**Yates Petroleum Corporation**

**Santa Fe Land SWD #1**

**September 12, 2012**

### **Addendum to Scope of Work**

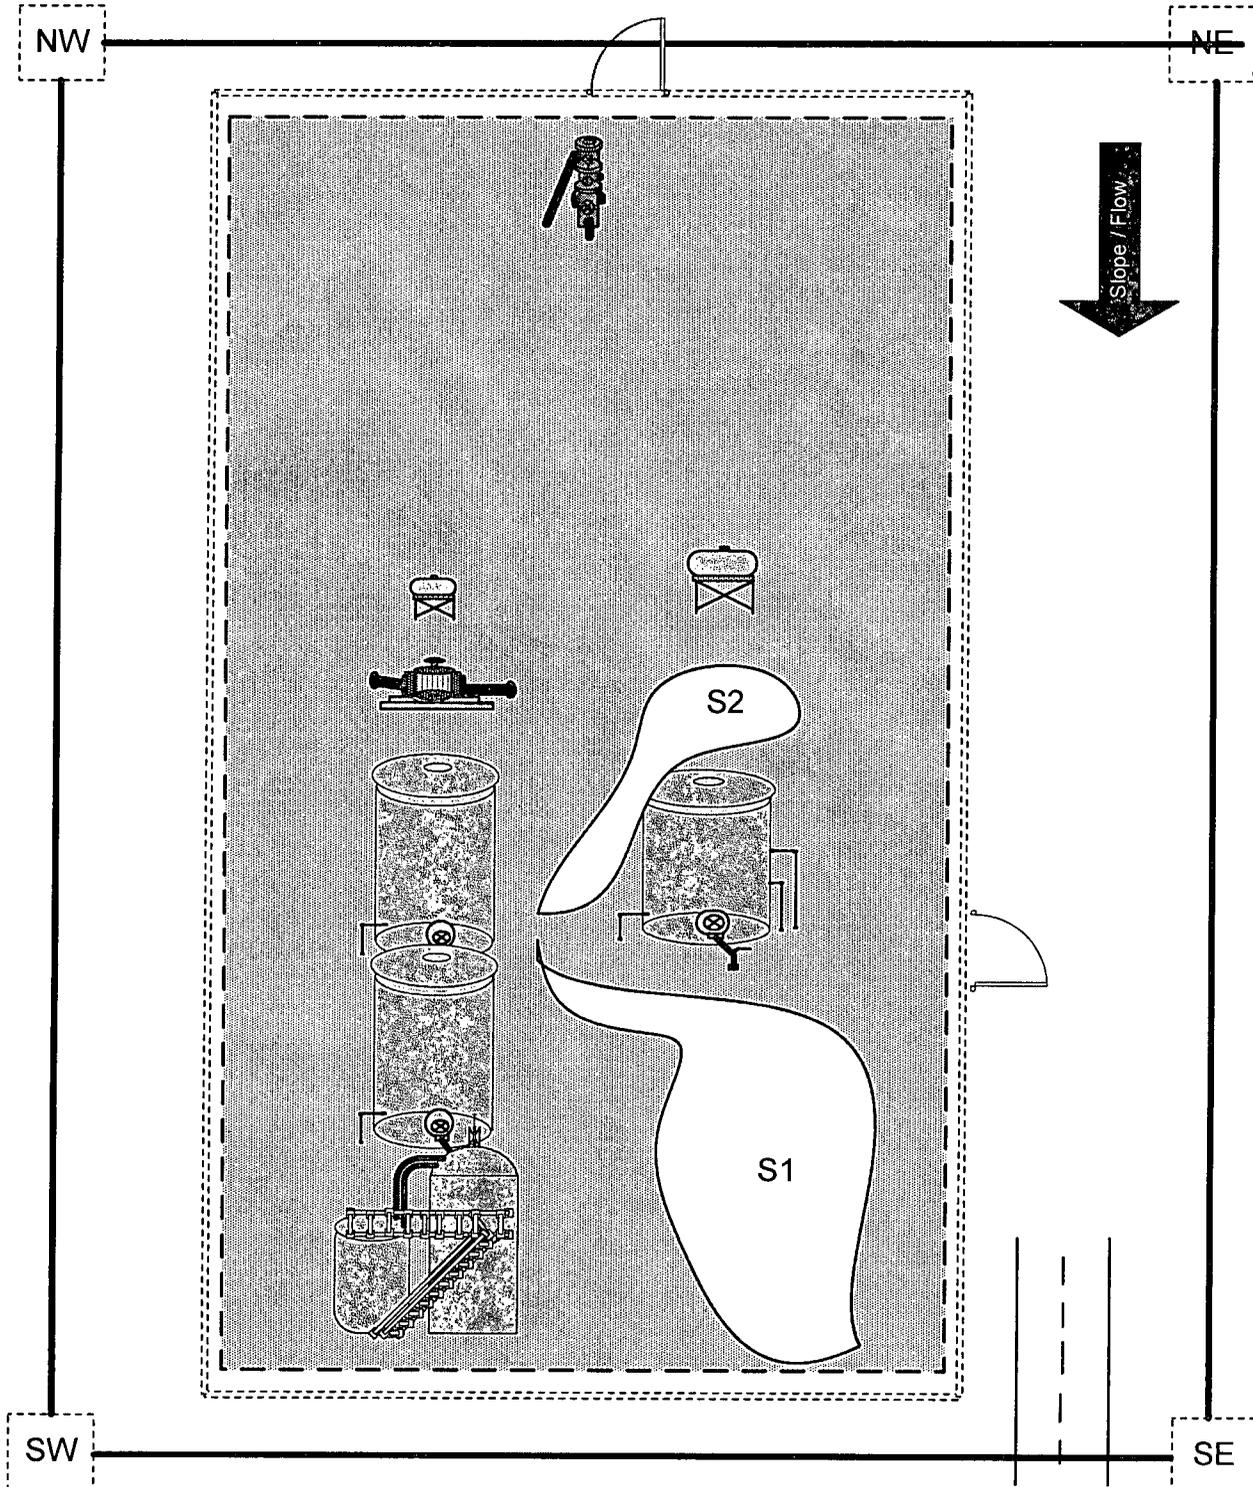
Since the above Work Plan was written a second spill has occurred (8/24/12). 180bbls were released and 160bbls were recovered. The release happened on top of the current area (S1 and S2). Yates Petroleum Corp. had commenced with the backfill in the S1 area when the spill occurred, so all the impacted backfill material was removed and hauled off to a NMOCD approved facility for disposal. After the S1 area was cleaned up to the natural rock barrier and the area was backfill.

When the spill occurred the S2 area had been dug down 2' to remove the initially impacted area. S2 was then delineated from 4' to 14' (results included in closure packet). It is Yates Petroleum Corp. feeling that the 6' sample was compromised since the rest of the sample data showed fairly uniform levels. During the sampling process we found the same natural rock barrier at 14' that the S1 area has at 5'. With the natural barrier at 14' and the liner that will be placed over the surface the Chlorides in place will be immobilized so Yates Petroleum Corp. will replace the top 2' of soil and proceed with the laying of the liner.
